MECHANICAL ADDENDUM NO. MADD-001

Project: Vaughan Willard P.S. – HVAC Upgrades

Date: December 31, 2025

MECHANICAL ROOM 201 - DEMO/NEW

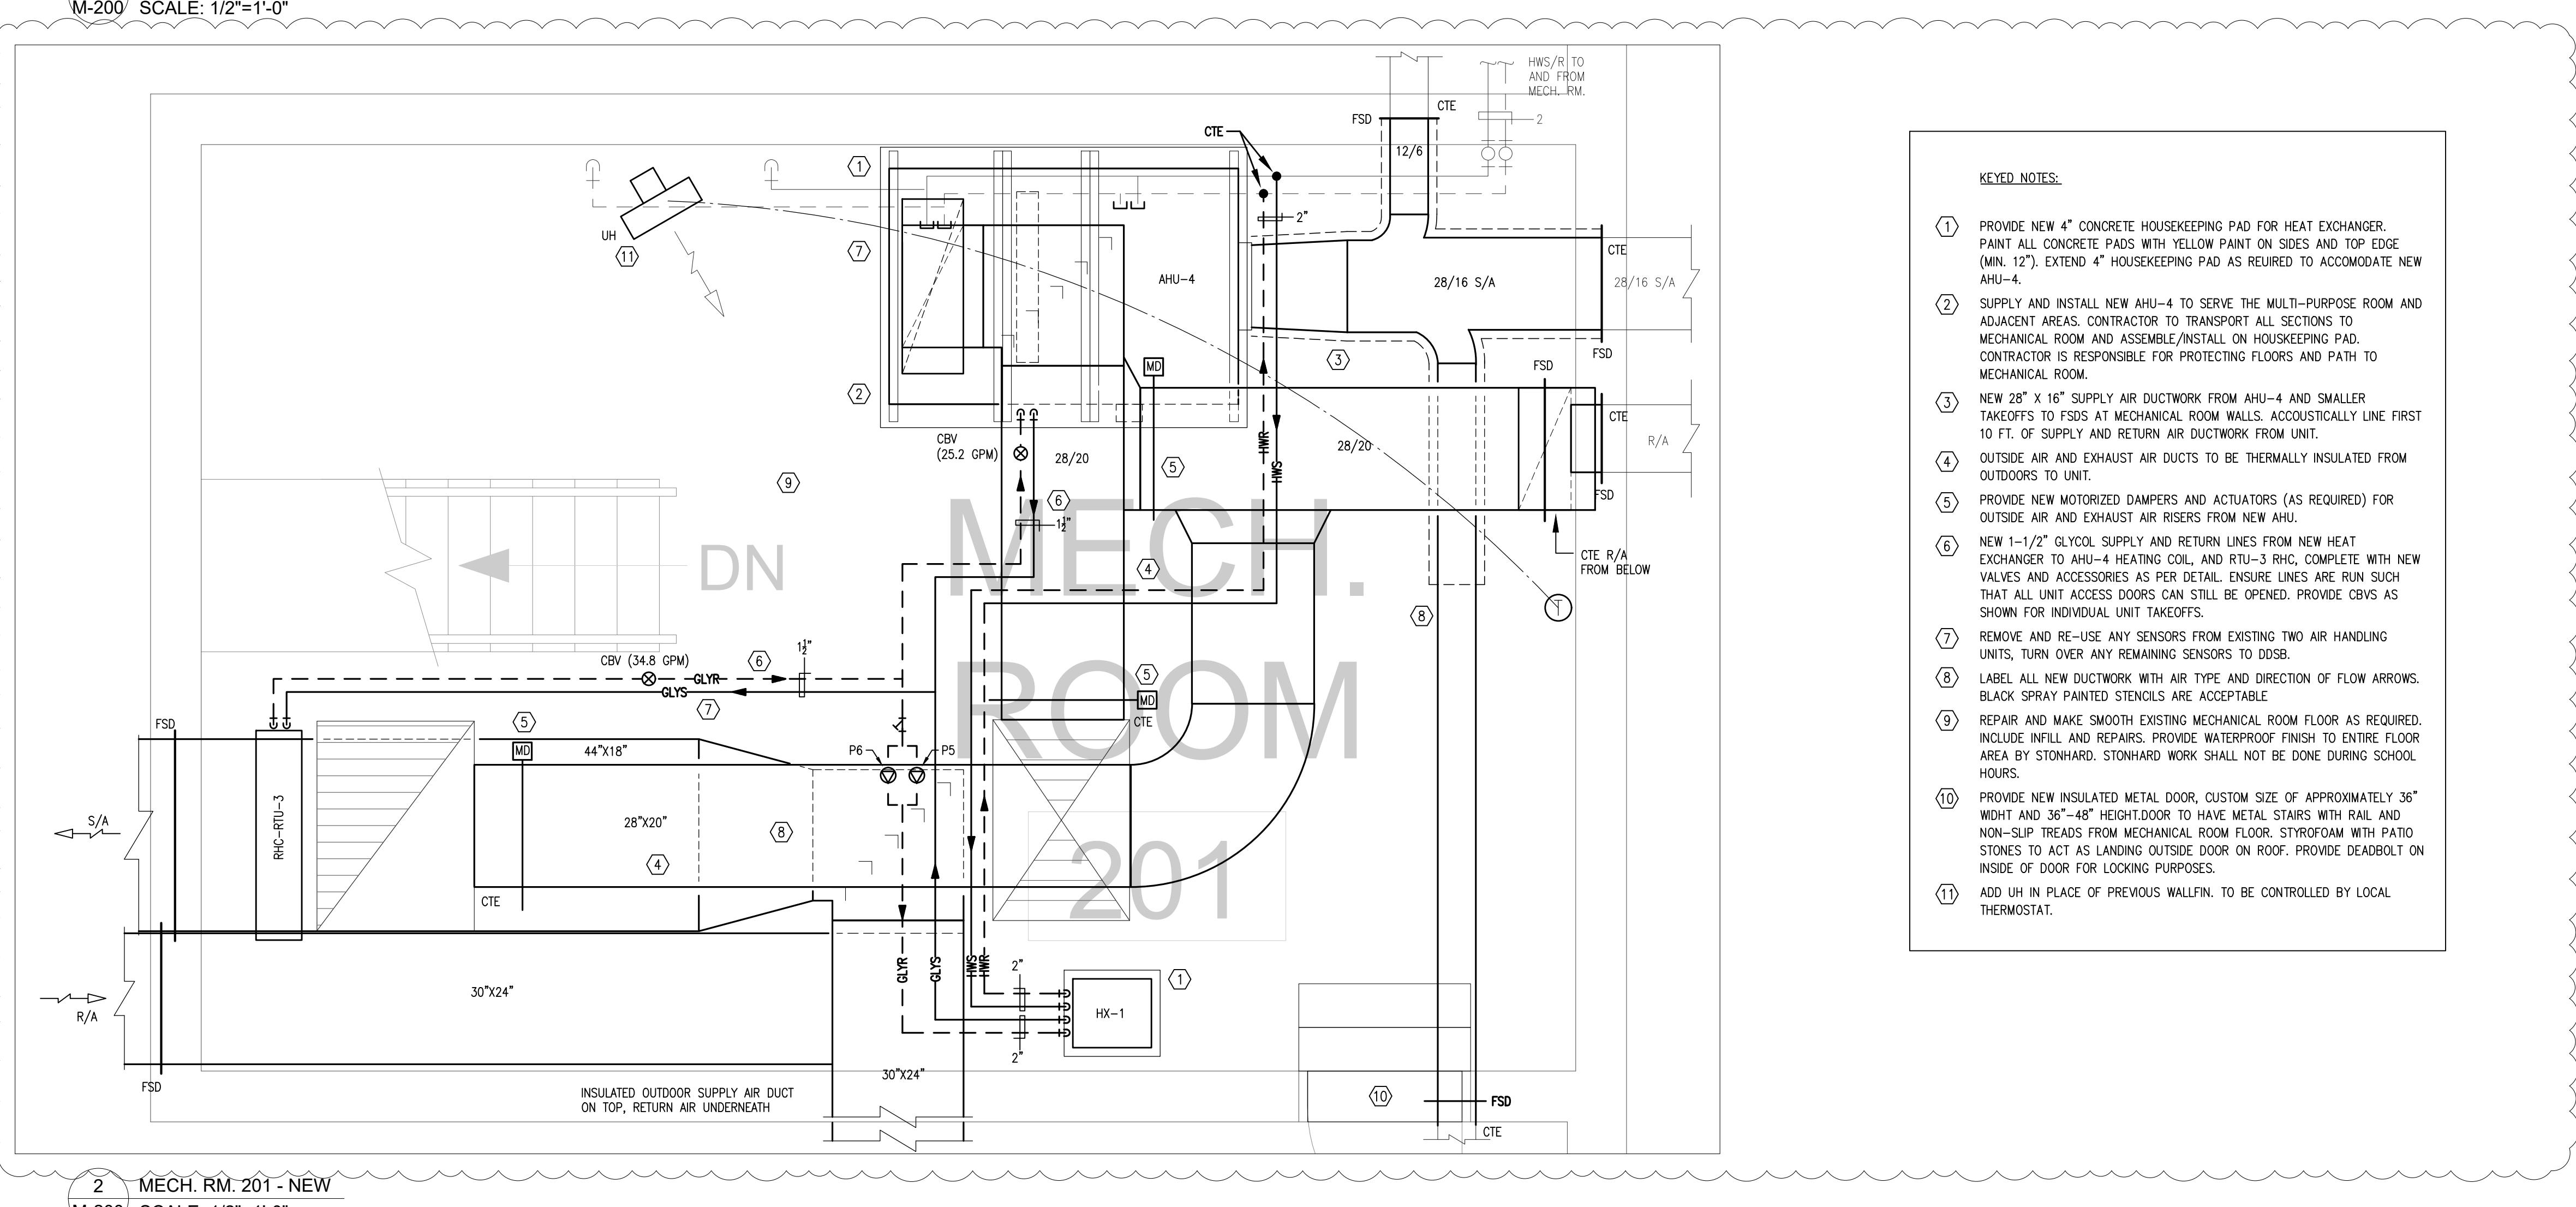
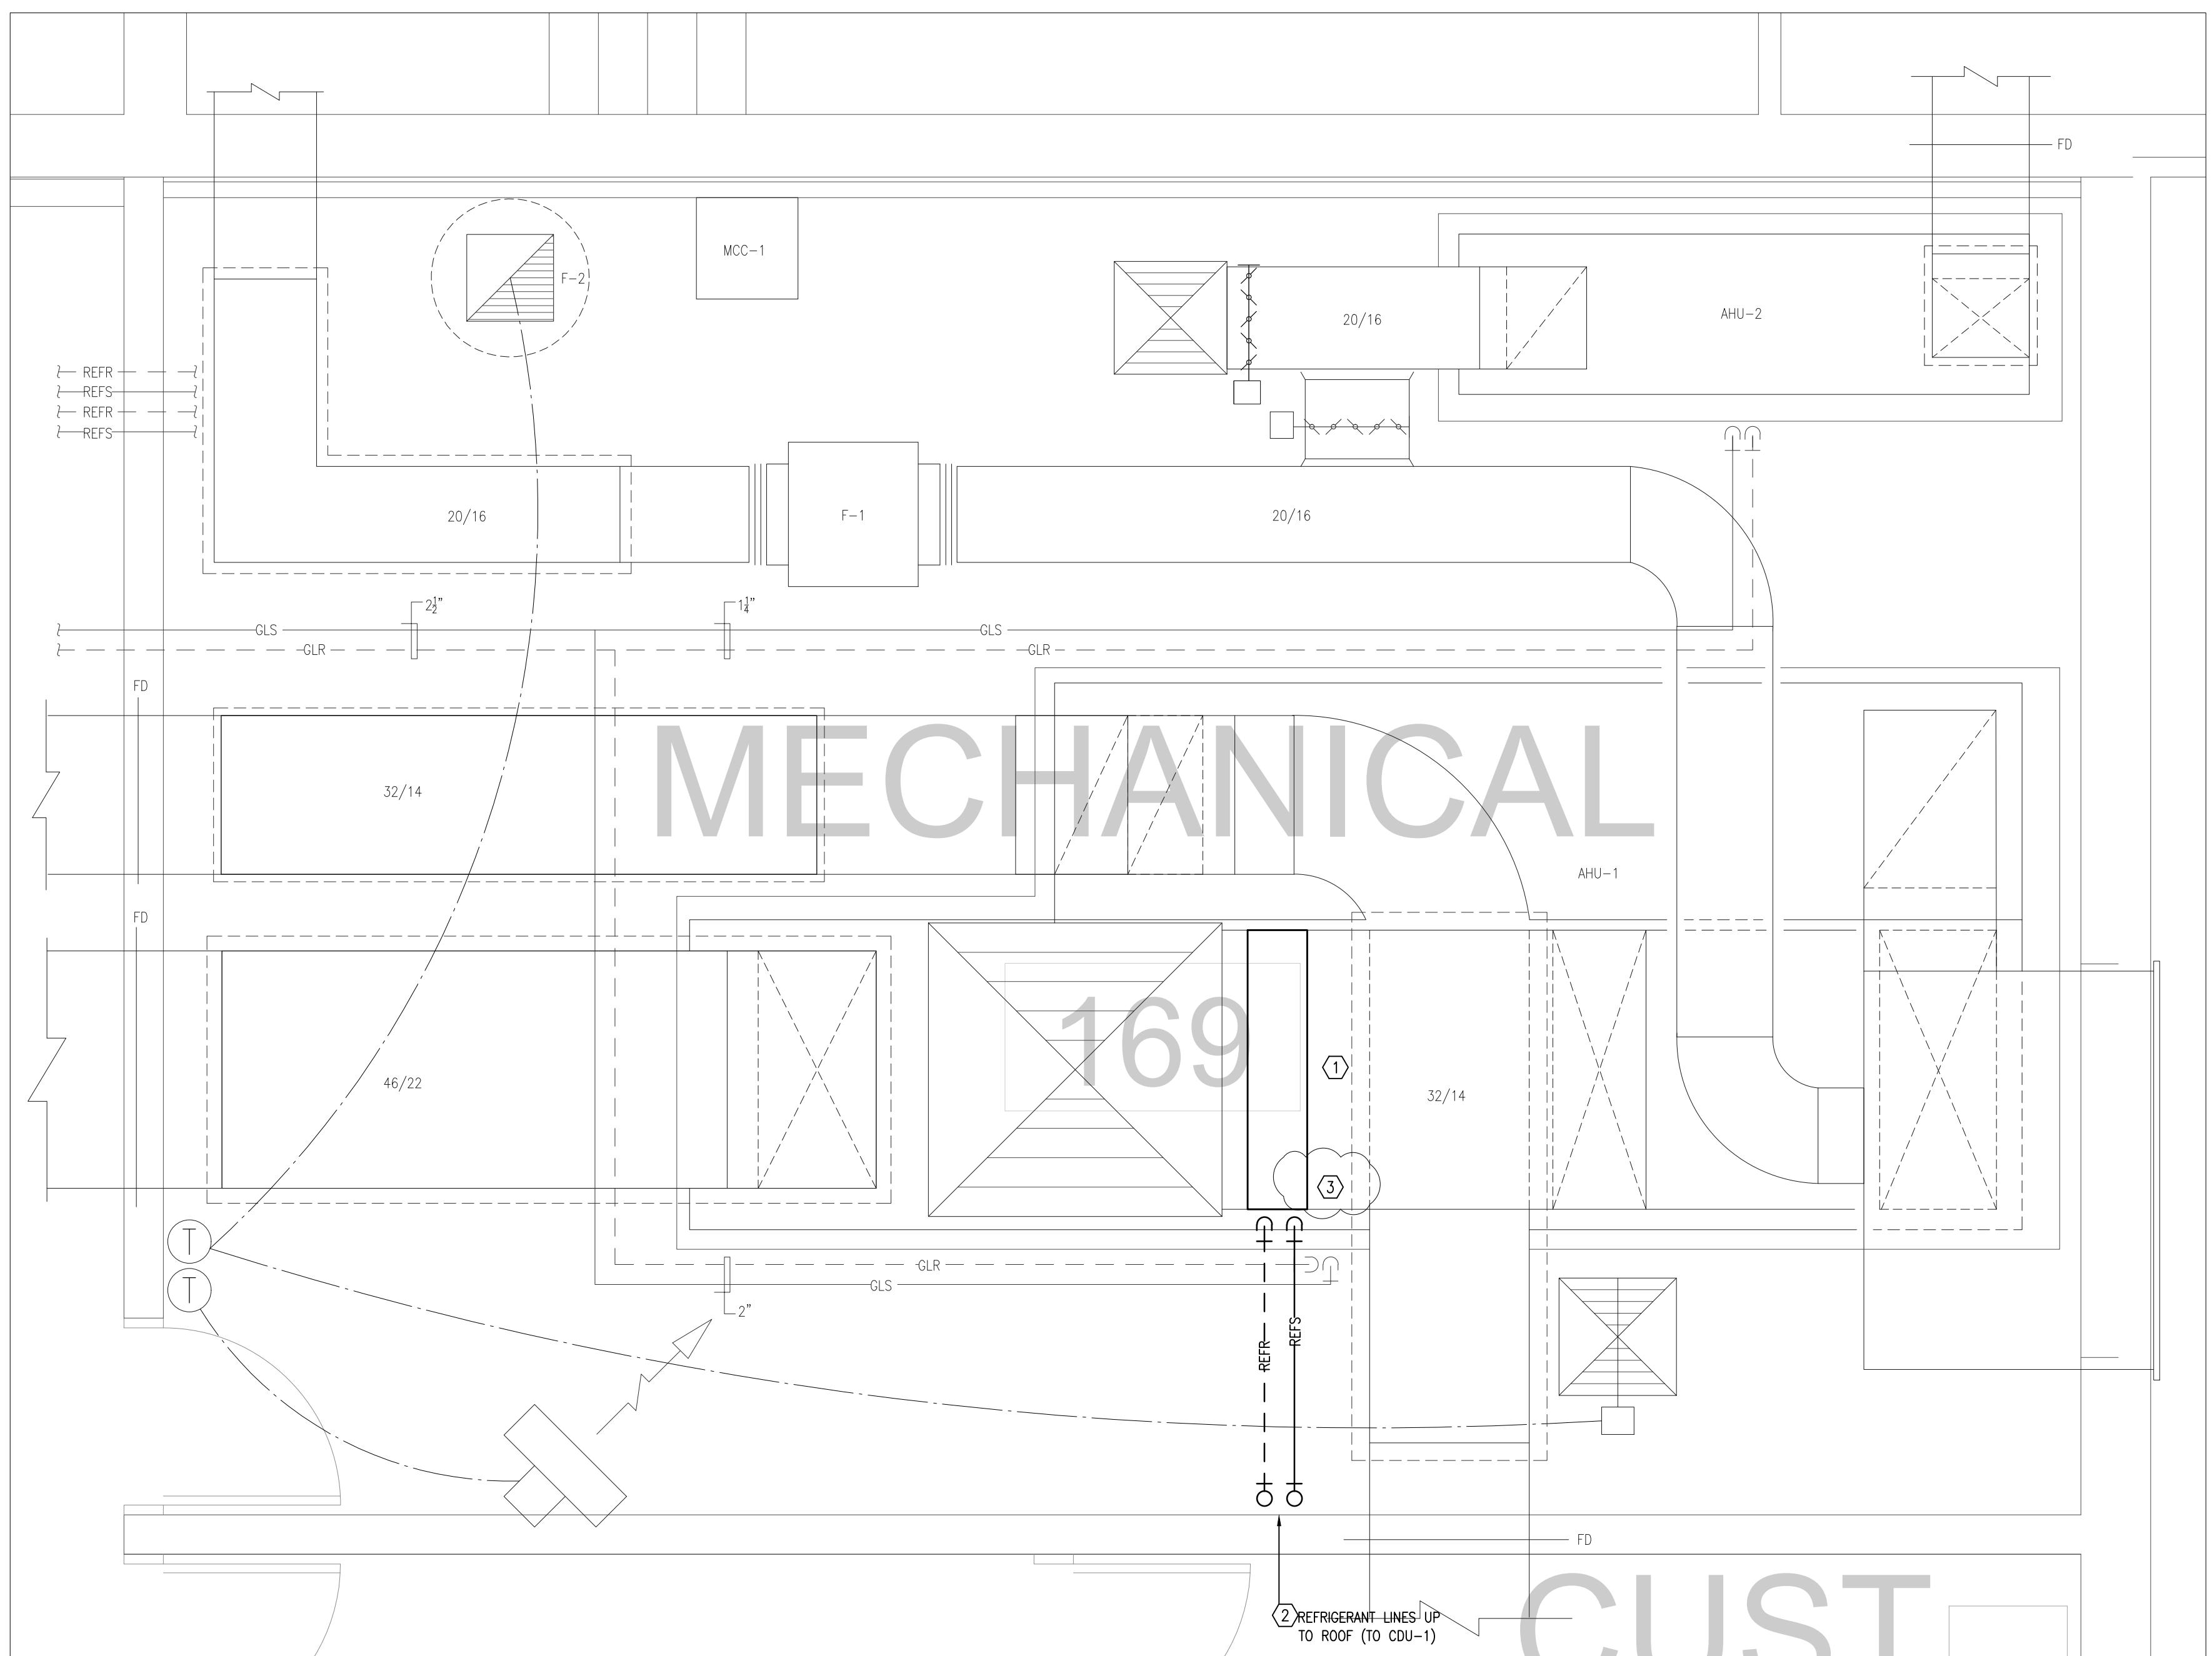
5. Refer to M-200 (Rev. 2) for highlighted changes.

- a. 1/M-200: removed existing exhaust fan and wallfin within mechanical room.
- b. 2/M-200: updated keyed notes.
- c. Glycol pumps to be in-line circulator pumps.
- d. Added unit heater in replacement of removed wallfin.
- e. Revised location of RHC-RTU-3 and associated supply and return ductwork.
- f. Added custom door and indoor steps at NE corner of mechanical room to allow for easy roof access.

1 MECH. RM. 169 - DEMO/NEW
M-201 SCALE: 1/2"=1'-0"

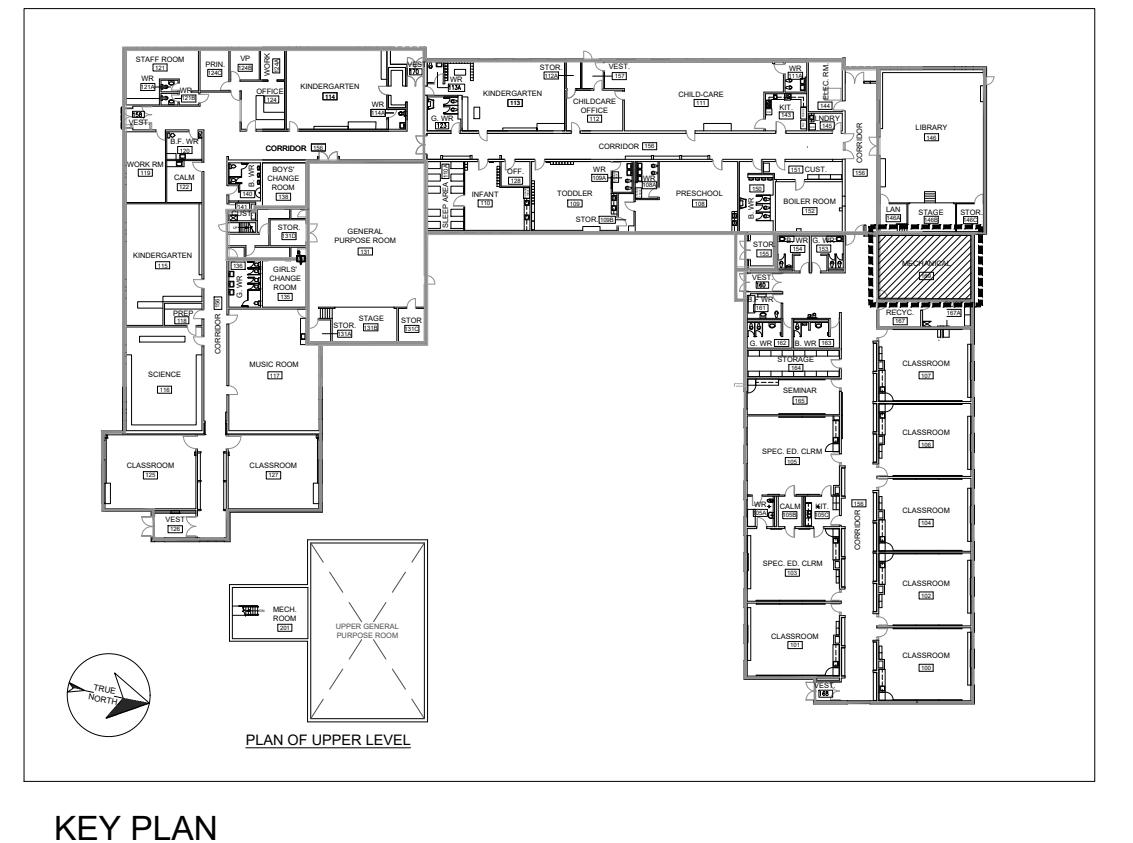
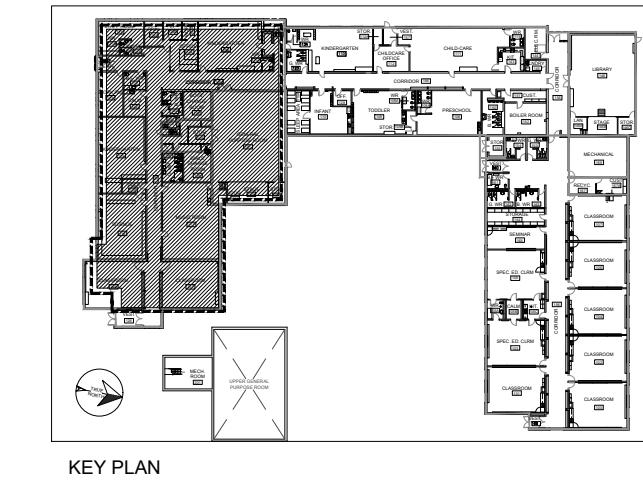
6. Refer to M-201 (Rev. 2) for highlighted changes.
 - a. Revised keyed notes – added keyed note 3.
7. Refer to M-202 (Rev. 2) for highlighted changes.
 - a. 2/M-202: revised keyed notes – added keyed note 4.
